LUSCOMBE AIRPLANE CORPORATION
DALLAS, TEXAS

SPECIAL SERVICE BULLETIN

SUBJECT: Rework Required to Permit Interchangeability of New Type (Square Tip)
Stabilizer with Old Elevators.

MODEL: 8A and 8E

FIGURE I---NEW ELEVATOR USED WITH OLD STABILIZER MADE PREVIOUS TO AIRPLANES SERIAL NO. 5075 (ROUND TIP TYPE)

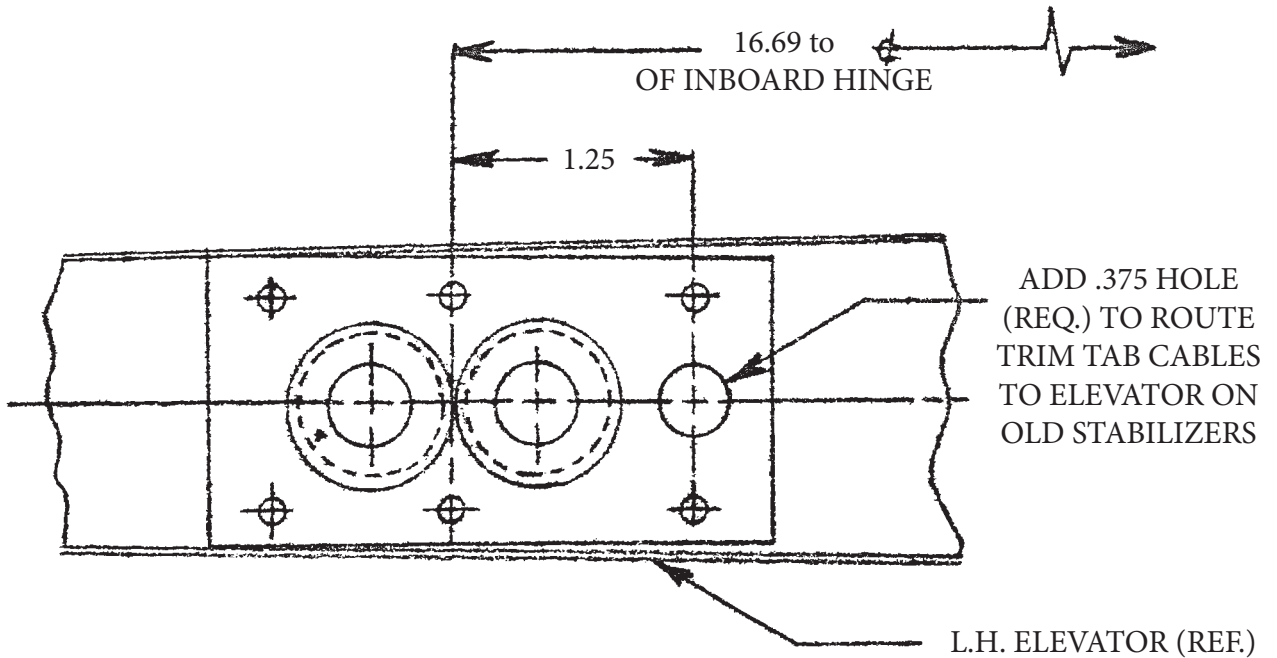
At the time the Silvaire stabilizer was redesigned to simplify construction the tab cable routing was modified to reduce tab system friction. The attached diagram has been prepared to describe the simple rework required when installing old elevators on the new stabilizer or vice-versa. Revision required is in the elevator spar and consists of merely revising the hole pattern through which the tab cables are routed.

REWORK DIAGRAM TO INTERCHANGE OLD ELEVATORS WITH NEW STABILIZERS AND OLD STABILIZERS WITH NEW ELEVATORS.
